SUBSURFACE WASTEWATER DISPOSAL SYSTEM APPLICATION

Town Or Plantation	Augusta 6/24B
Street Division Lot #	Eight Rod Road

Last: Laliberty First: Noel

7/7/92 revisions as part of redesign due to system malfunction. See attached pg 2a of 3 for discussion of malfunction.

Observations: related to malfunction.

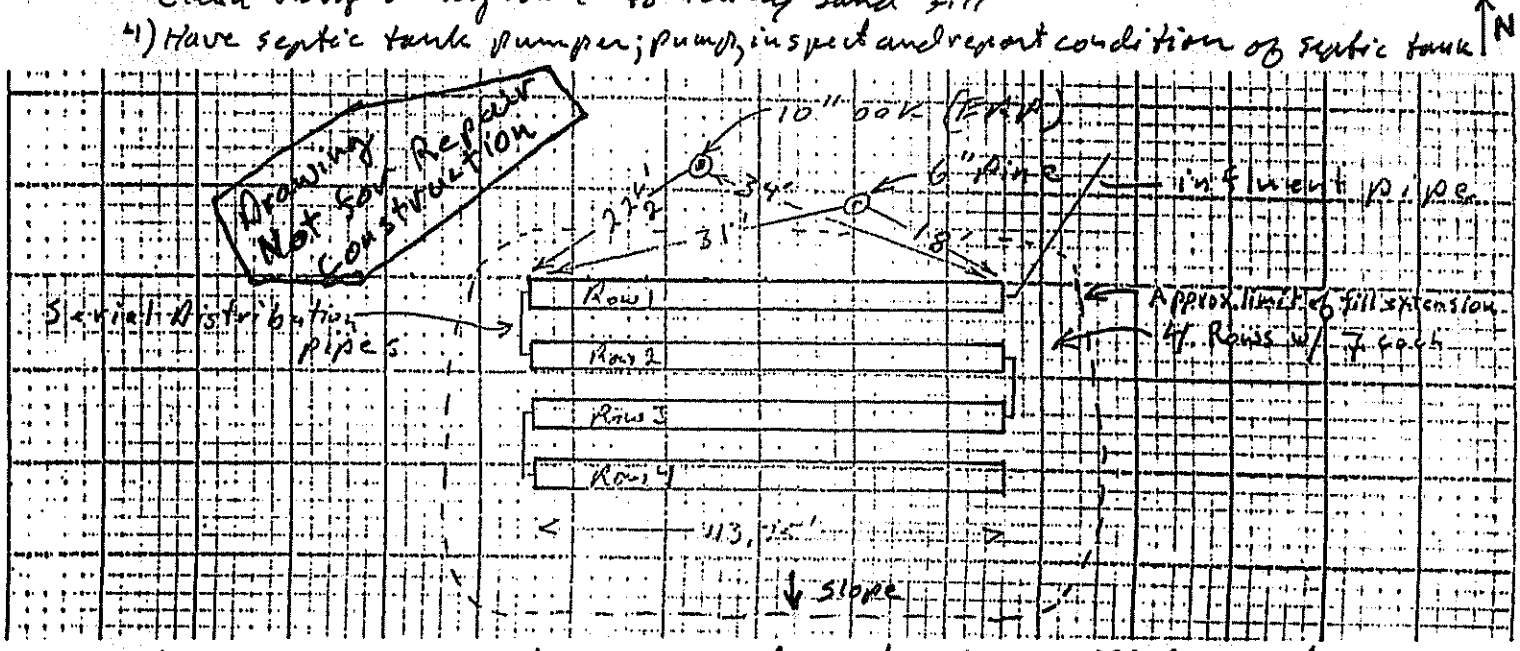
1) ERP 10" oak is misslabelled, should be 10" maple (on drawing below)
2) ERP 10" oak and 6" pine may be transposed on drawing below. If so system may have been constructed 16' along slope towards the east and ~3' downslope. If transposed ~~and~~ during construction this would tend to provide a more conservative separation distance. Difficult to determine if trees were transposed because pine tree ~~has~~ has been removed.

3) Rows 3 and 4 both full of water.
4) Malfunction originally observed as seepage at SE corner.
5) Top of infiltrators is approximatly 3" below design elevation (average)

6) Infiltrator rows approximatly 4" pitch (i.e. not level) average per row, pitch is downwards toward SE corner.
7) Visual inspection thru end caps of rows 3 and 4 indicates infiltrator base (feet) are pushed into base grade ~ 4".

8) Wire guage in Row 1 indicates ~ 4" of sludge like material ~~in~~ above bottom of trench elevation.
9) Silt loam fill observed @ SW end and edge of Row 4

10) Site grading channels surface water runnoff directly over disposal area
11) Drainage area as constructed was rotated about 20° counter clockwise about ~~the~~ NW corner.

1) Rebuild at same location w/clockwise 20° rotation per original design.
2) Raise bed 12" to improve separation distance
3) Replace any silt loam ~~fill~~ fill within footprint of fill extension with clean very sandy loam to loamy sand fill
4) Have septic tank pumped; pump, inspect and report condition of septic tank

5) carefully construct replacement system to specified elevations and carefully back fill infiltrators to a avoid pressing them into subgrade
6) Divert surface water runoff away from drainage area.
7) Contractor discuss repair plan w/ ~~and~~ site evaluator prior to construct
8) Contact site evaluator if any questions prior to construction.
